CITY OF KIRKLAND
Planning and Building Department
123 5th Avenue, Kirkland, WA 98033
425.587.3600 ~ www.kirklandwa.gov

To: Design Review Board
From: Scott Guter, Planner
Date: December 8, 2016
File No.: DRV16-02789
Subject: **EASTSIDE PREPARATORY SCHOOL EXPANSION – FINE ARTS BUILDING CONCEPTUAL DESIGN CONFERENCE**

EASTSIDE PREPARATORY SCHOOL
TALI HALL PROJECT

City of Kirkland Design Review:
Conceptual Design Conference
November 2016

ALTERNATIVE 3 - FORMAL DEVELOPMENT

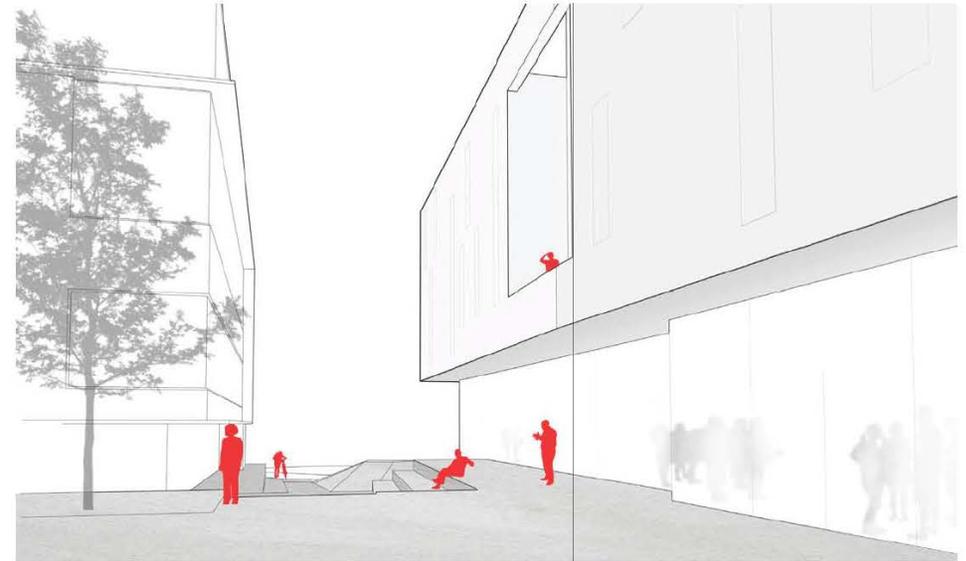
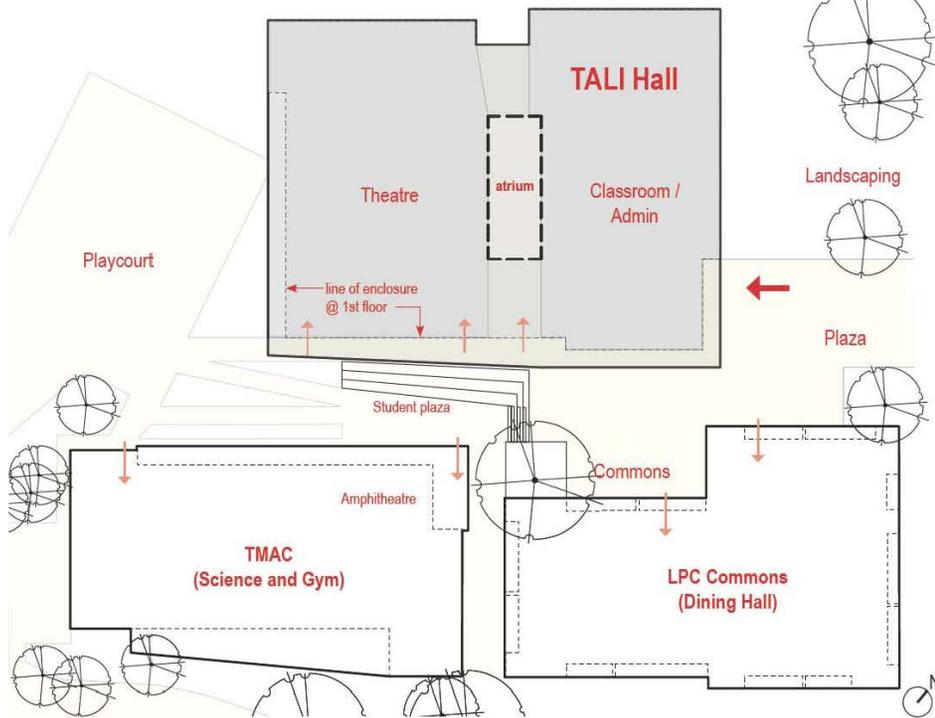
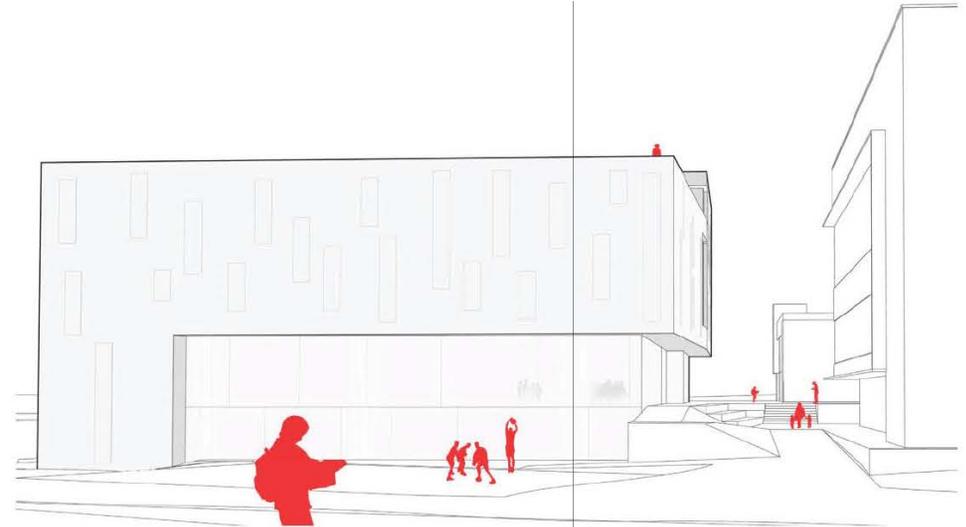
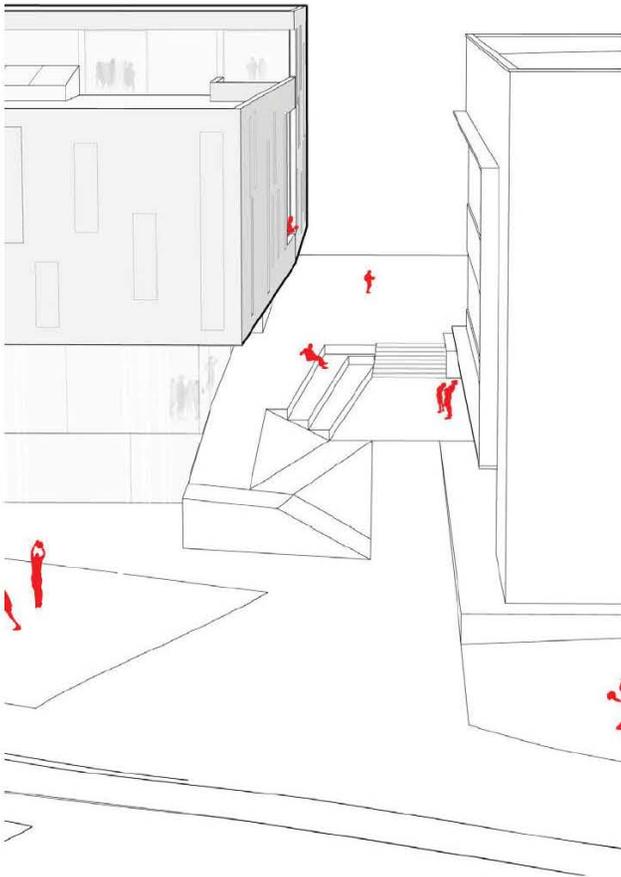
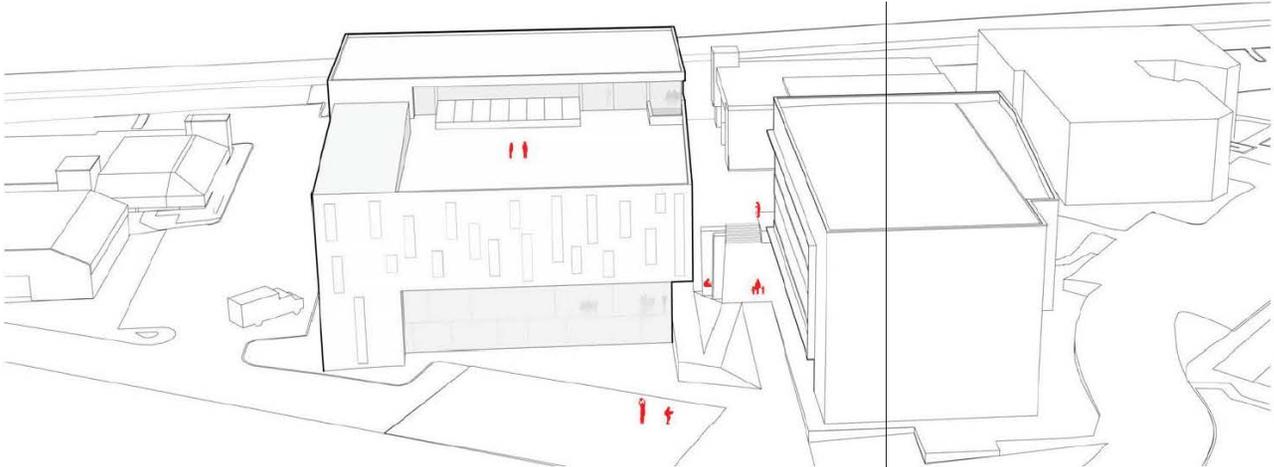
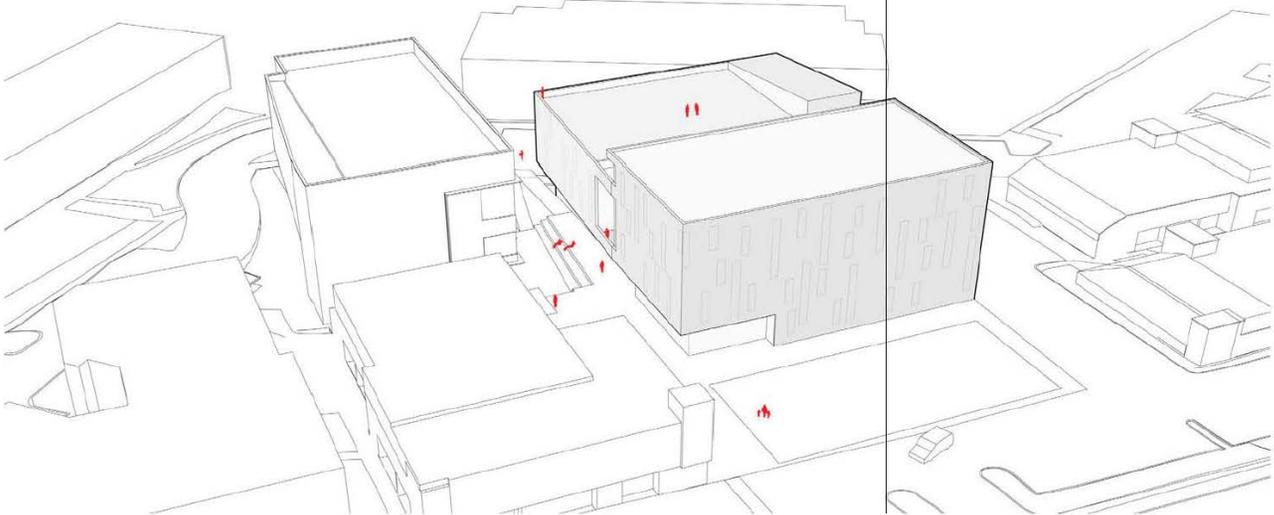
1. What are the key vantages of the project?
2. Identify appropriate mitigation techniques for building massing of the proposed buildings. Possible techniques include vertical and horizontal modulation, corner treatment, and roof forms. The applicant has provided several massing schemes including a preferred option (Alternative 3) for the DRB's review and comment (see Attachment 3).
